This is to request a Class II permissive change for FCC ID: DVE-RPC24, original grant date: 05/09/2019 and Class II permissive change for IC: 24775-RPC24, original grant date: 05/17/2019

The difference description between the new model: **RP-C-16B-F-24V** and original models: **RP-C-12A/B/C-F-24V** is described below.

Below the PCB Floor plan is shown where the Application MCU that is changed is highlighted.

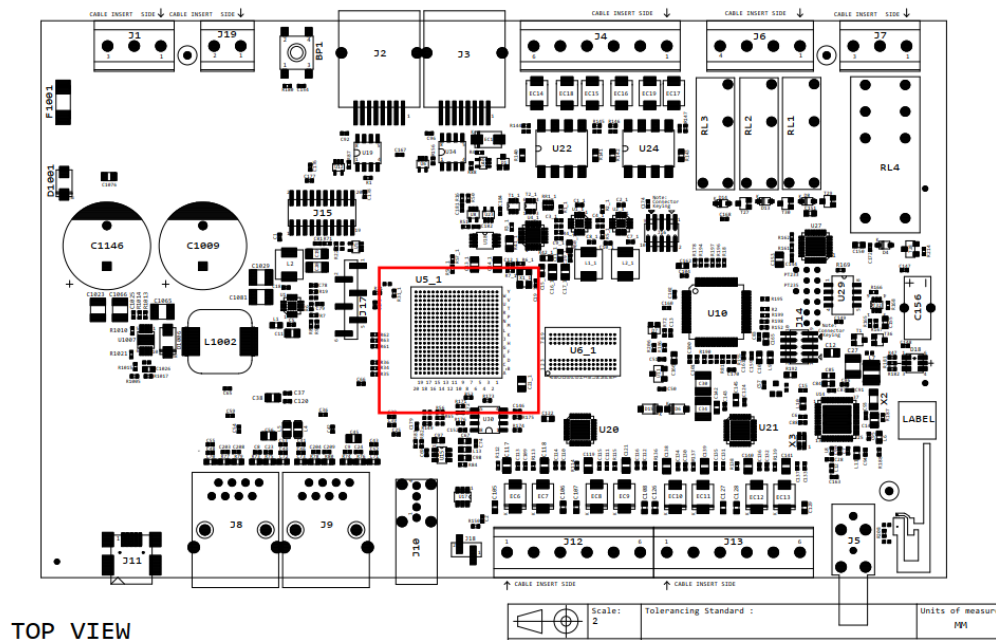
The same type of IOs exist between the current models, RP-C-12A/B/C and the new model RP-C-16B where the only change is to replace the current Application MCU (not related with radio) to another higher performance Application MCU.

Exactly the same peripherals are used and a copy of schematic and layout is done.

So all the function blocks when it comes to Radio(MCU, Antenna+ discrete component), IO types, Ethernet, USB, Power Supplies, and local COM ports are the same.
